STAFF COMMENTS FOR PLANNING COMMISSION

SITE PLAN: **AFP-06-047**

TITLE: **Observatory Heights**

REQUEST: **AMENDMENT TO FINAL PLAN APPROVAL**
For architectural model, grading, and house
footing revisions

AFP-06-047
#5
11-15-06

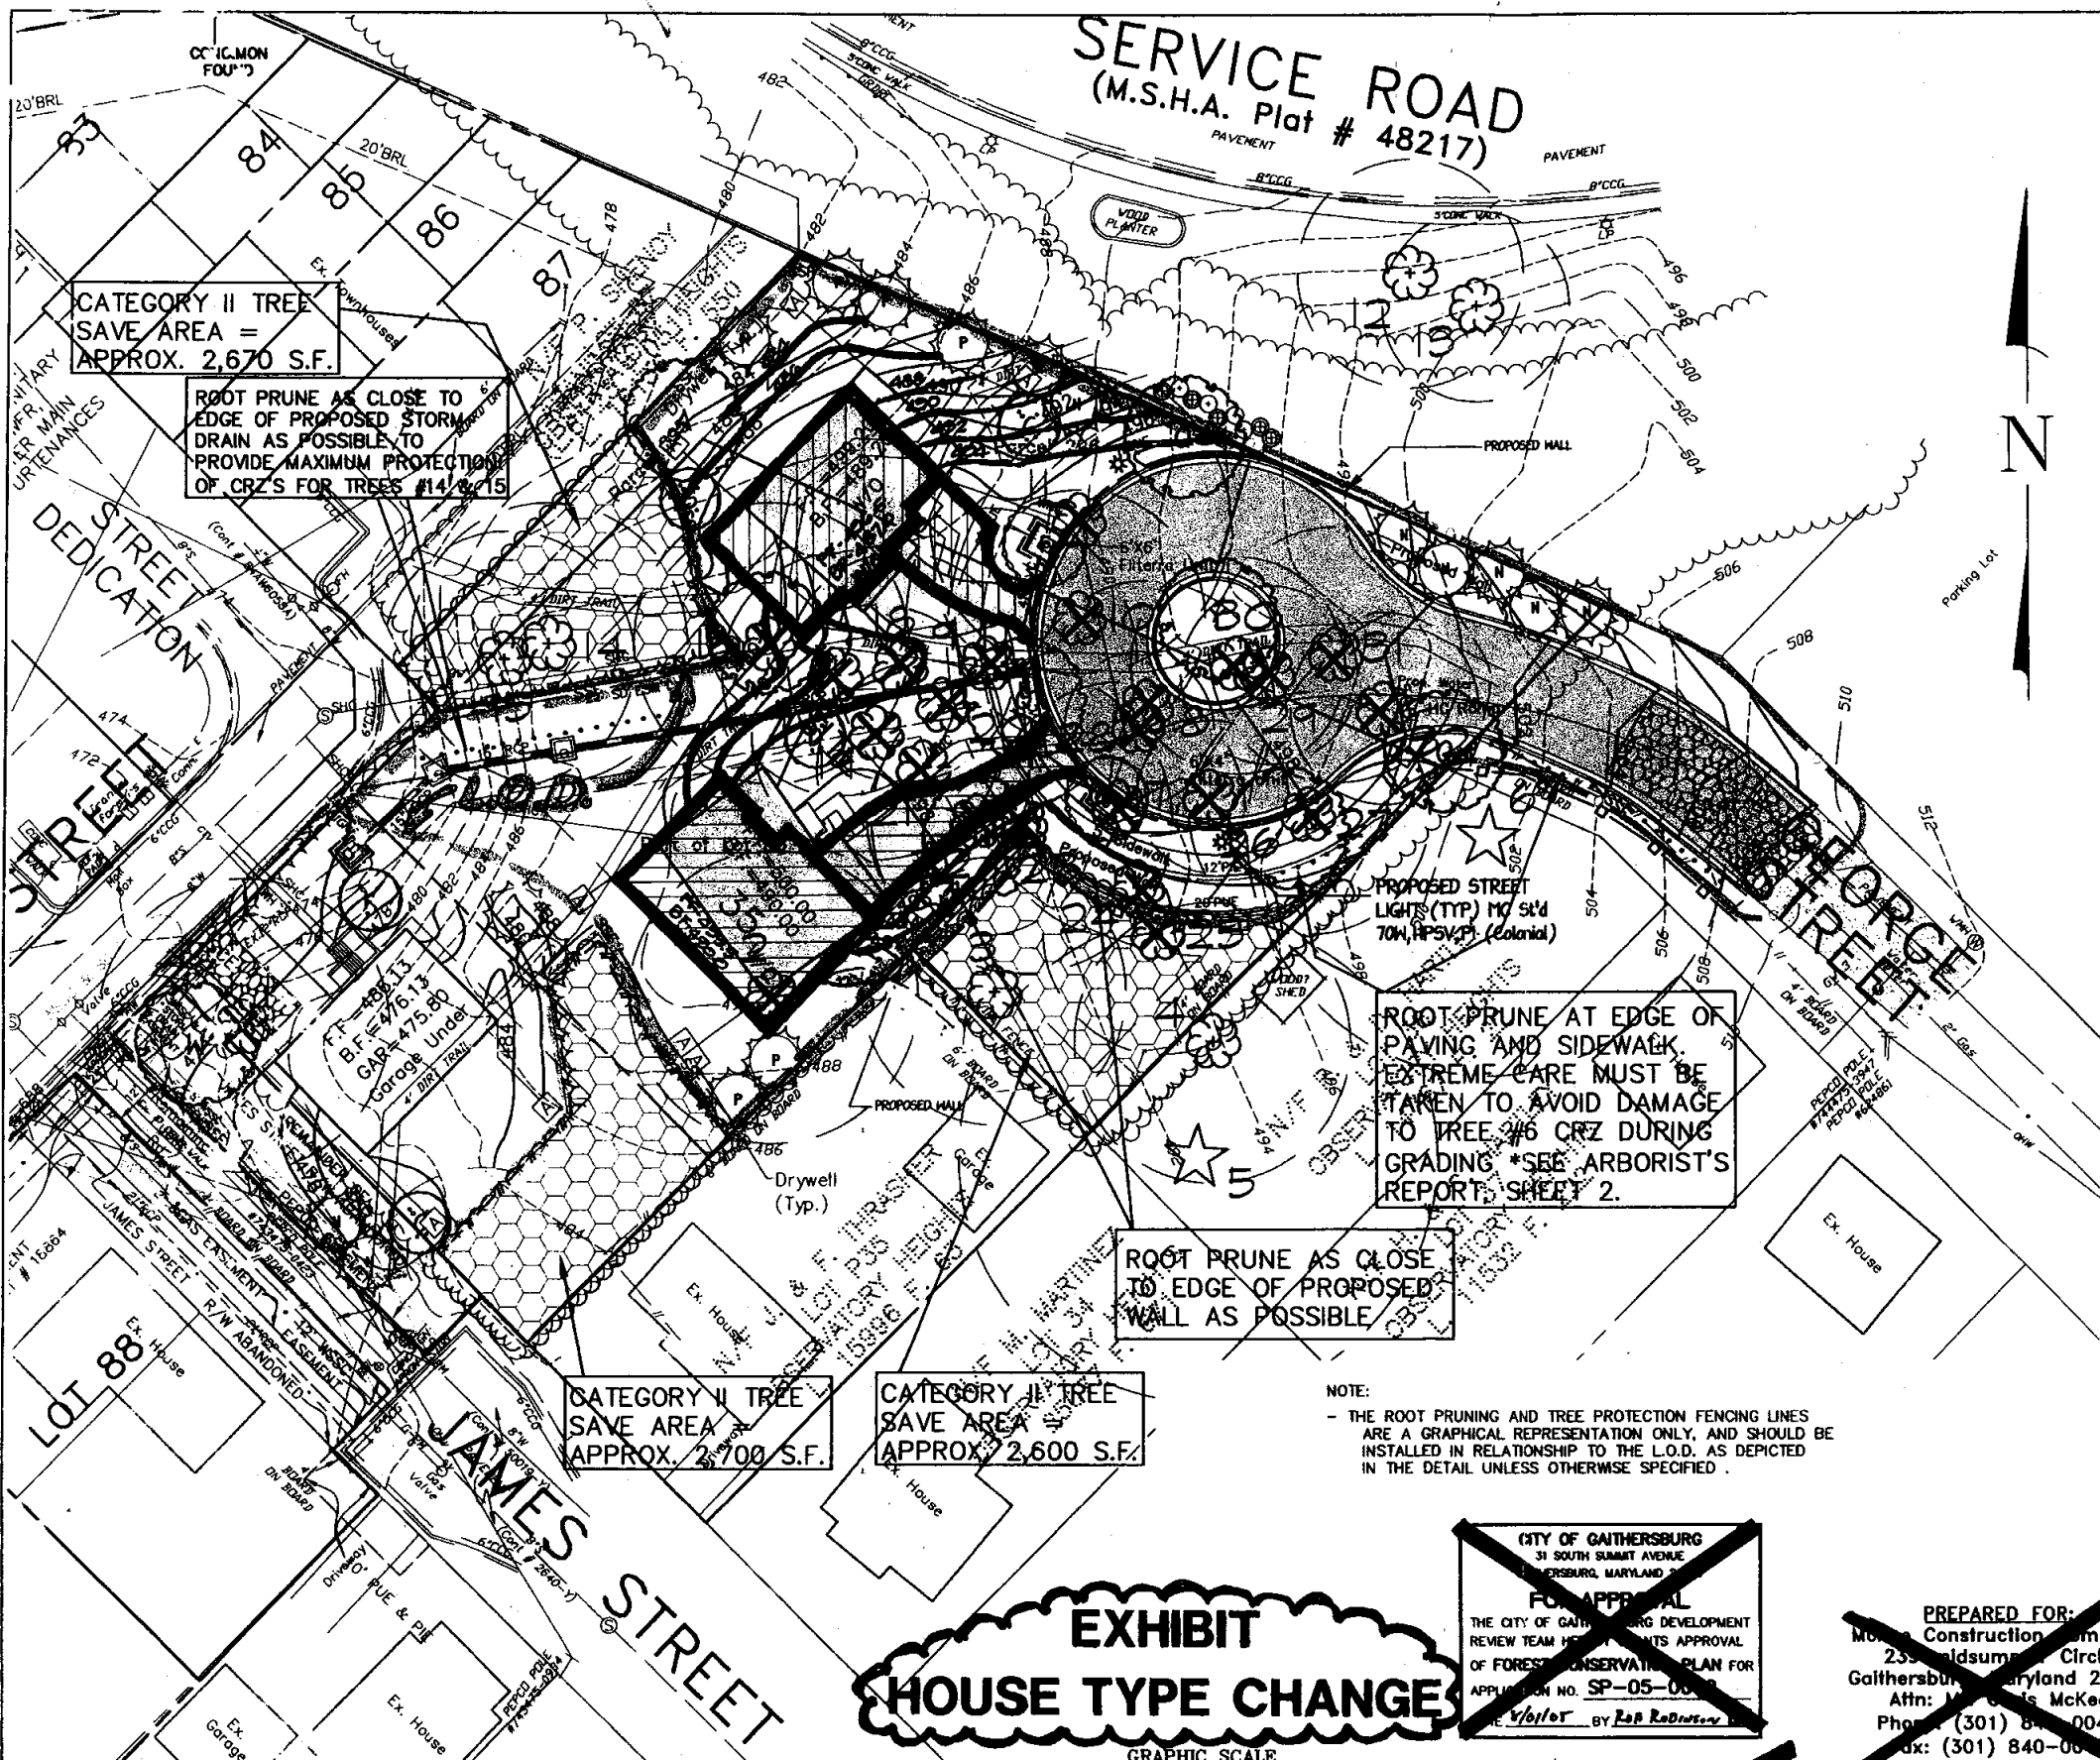
The two lots were originally part of a three-lot subdivision that was granted concept site plan approval by the Planning Commission on March 2, 2005, with six conditions (Exhibit #3), and the subsequent final site plan approval on May 18, 2005, with twelve conditions (Exhibit #4). Many of the conditions relating to the site plan, SP-05-0002, are still in place and staff has been working with the applicants to ensure the tree save and forest conservation areas are well protected. The remaining conditions will be carried through as a part of this approval. The proposed forest conservation plan shows the new footprints of the houses and they will not encroach into the limits of disturbance, the forest conservation easements, or storm drain easements. The site grading has been modified slightly to accommodate the new house footprints.

LOT 91 Observatory Height
 122 George Street
 Gaithersburg, MD 20877

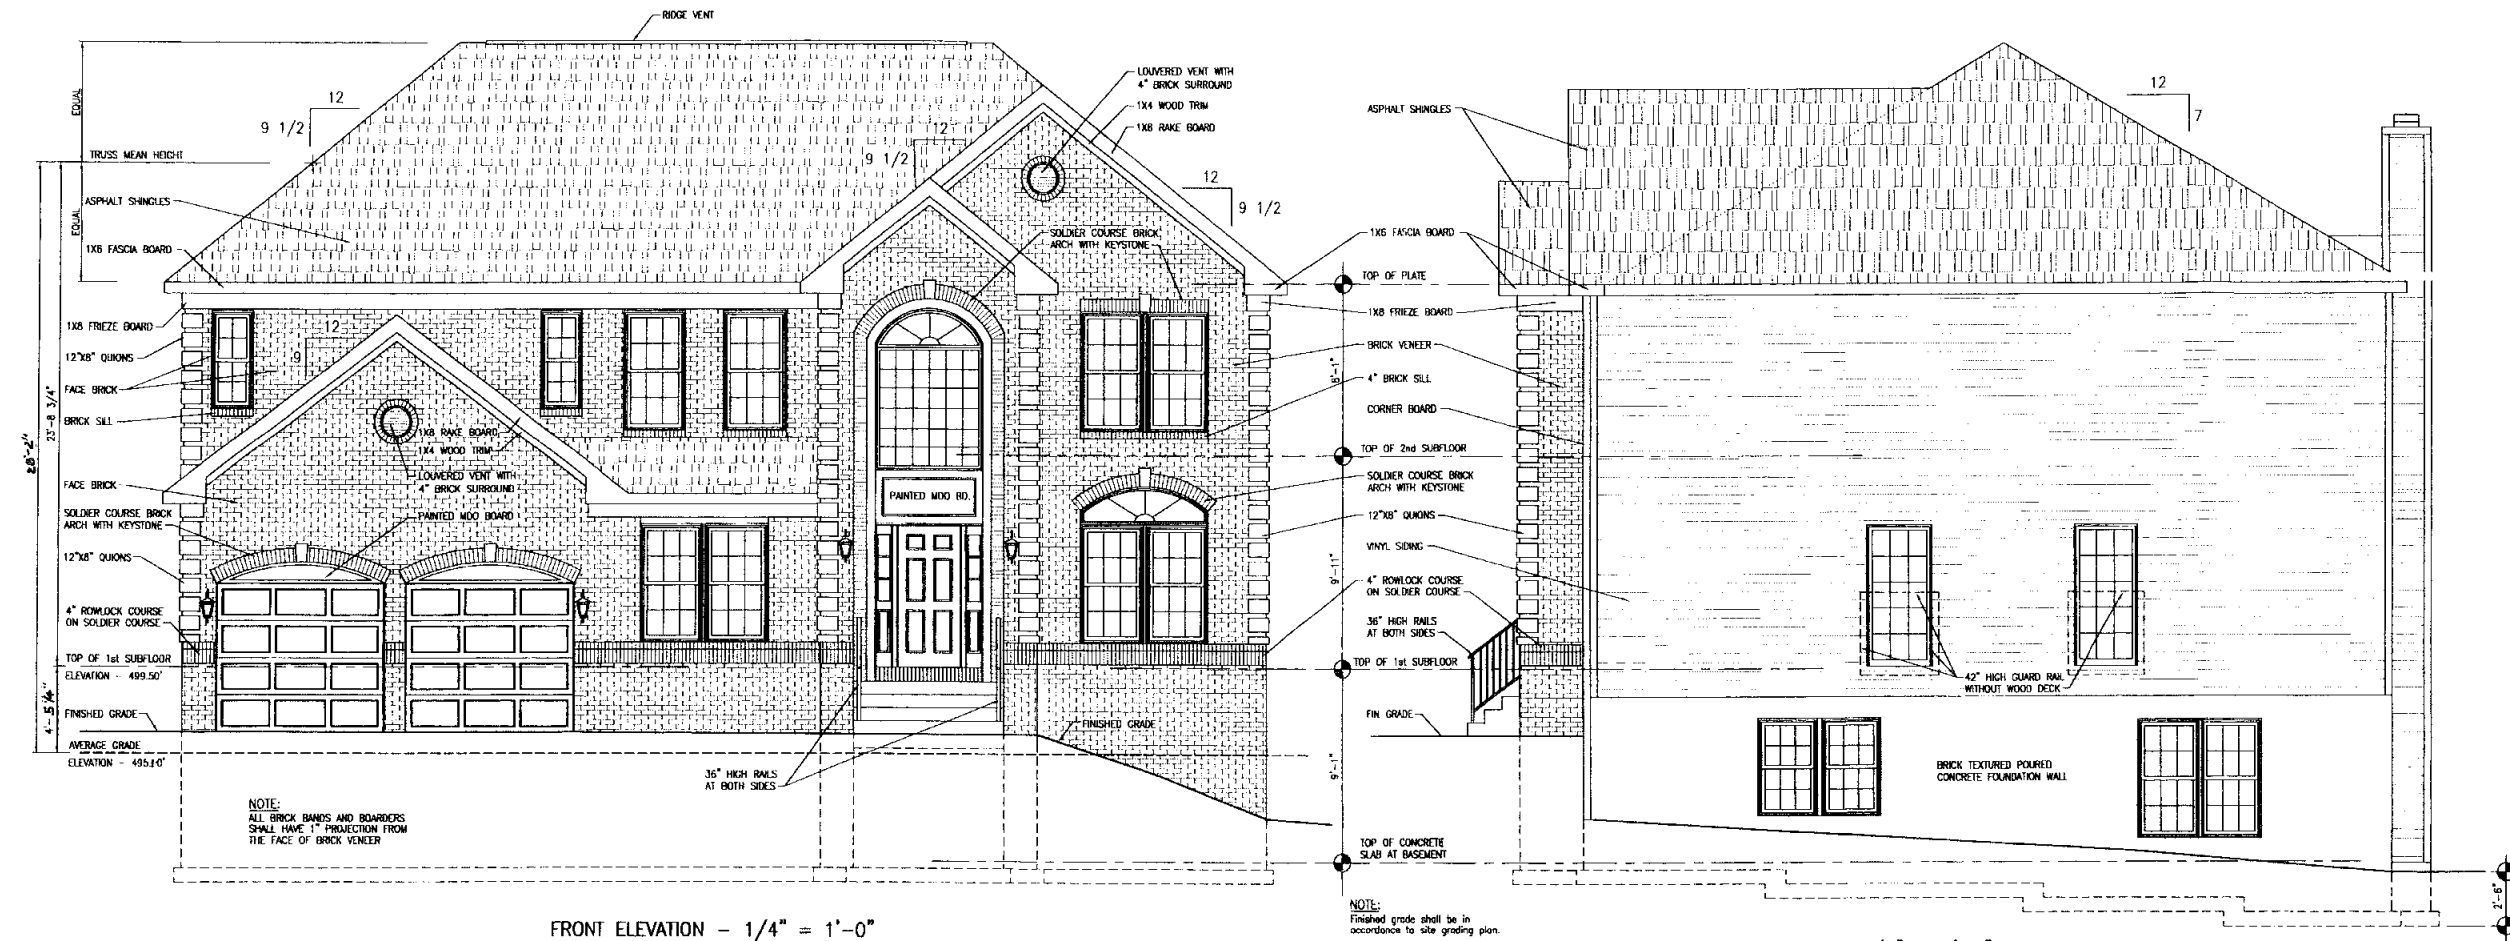
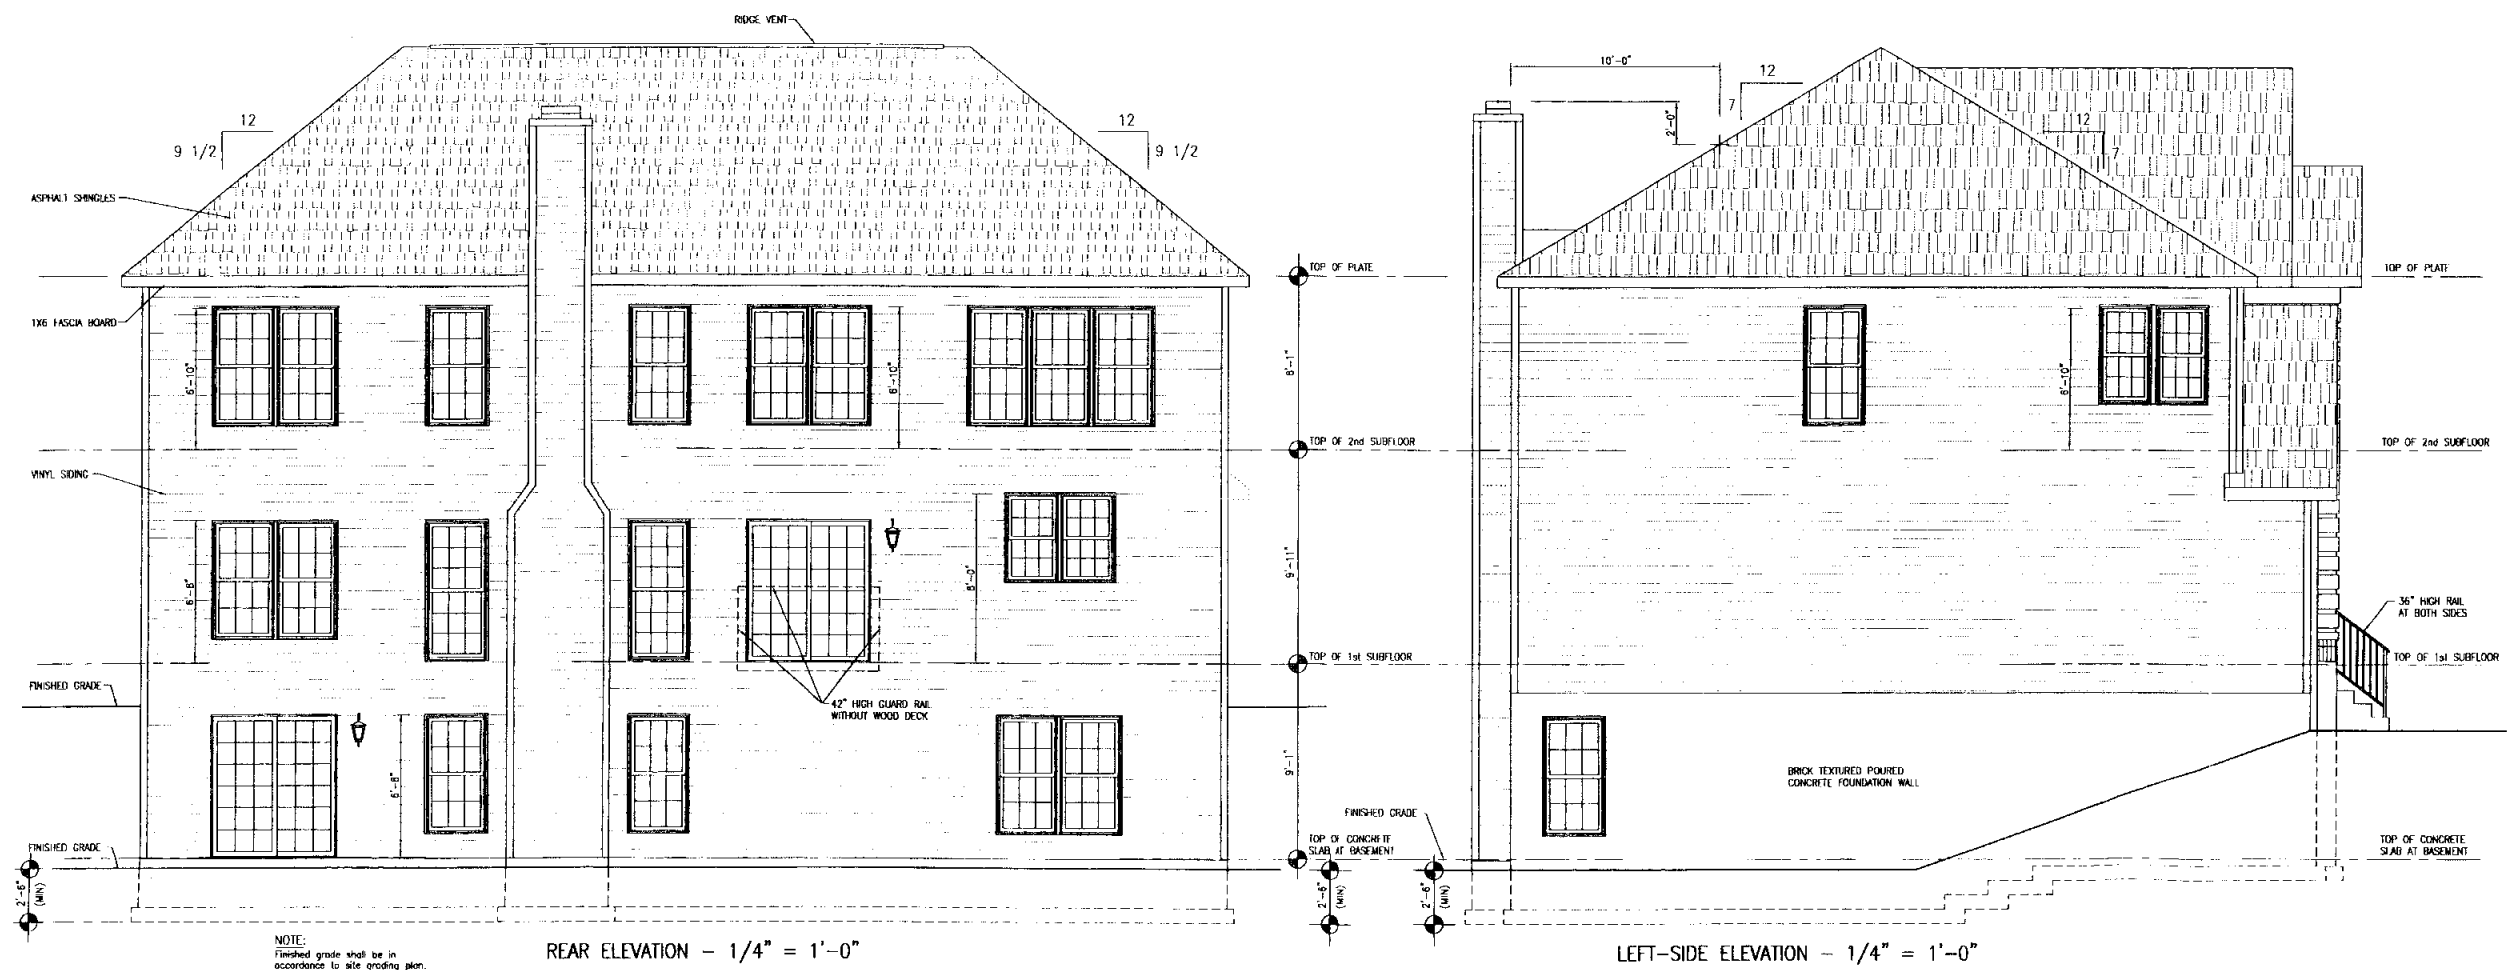
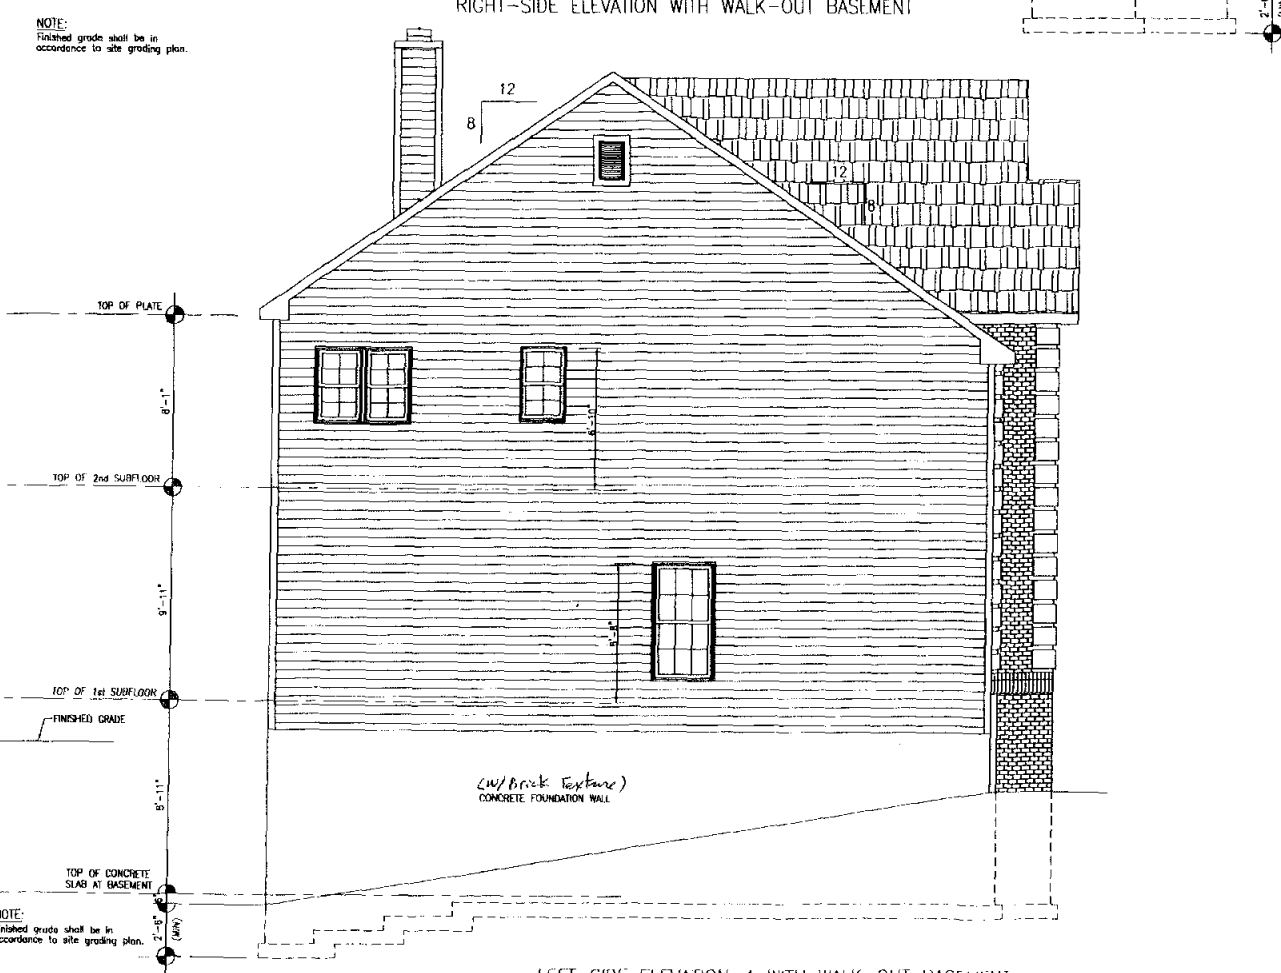
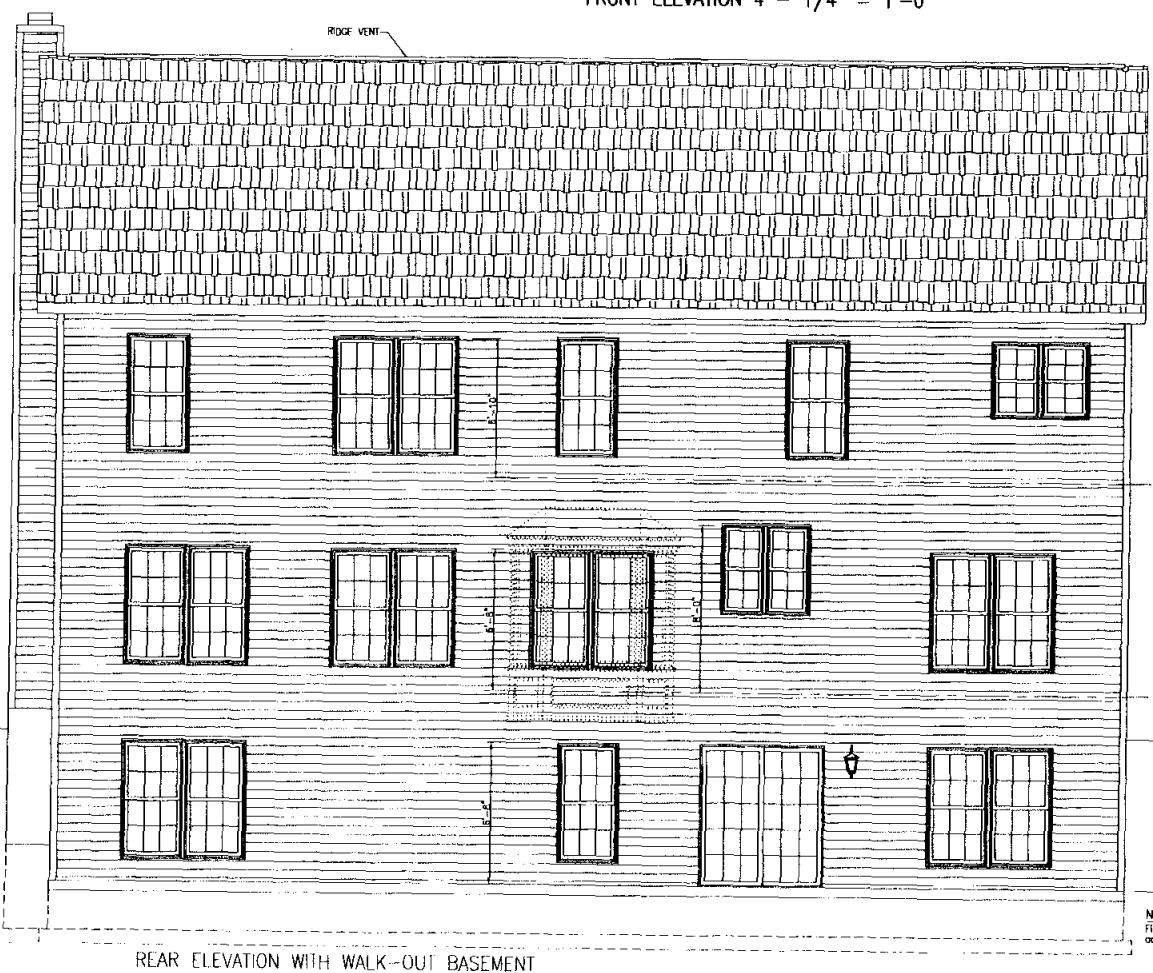
The proposed elevations and footprints of the houses on lots 91 and 92 show an increase in total square footage (Exhibits #7 and #8). The previously approved architectural elevations have been included (Exhibits #9 and #10). The square footage for lot 91 has changed from 2,439 square feet to 3,454 square feet. The square footage for lot 92 has changed from 2,439 square feet to 3,266 square feet.

The proposed architecture retains the two-story front-loaded single family detached units that were previously approved. The exterior materials and general house styles are the most prominent changes to the architecture. For both proposed houses, the front facades will have brick veneer and the remaining sides will have vinyl siding. The new architecture does not have front porches, but there is room for future decks to the sides of both houses, as shown on the site plan. The decks will not extend past the yard setback lines (10 feet on both sides). Staff is requesting the applicant revise the rear elevation on Lot 91 by changing the glass doors to windows. The doors could lead to a deck, which is not allowed at the rear of the house due to the building restriction lines.

Another notable change is the new architecture will have two double garage doors as opposed to one larger garage door. On both lots, the exposed foundation walls on the right and left elevations will be brick textured poured concrete.

- 1. The applicant shall replace the sliding glass doors with windows on the rear elevation of Lot 91.**
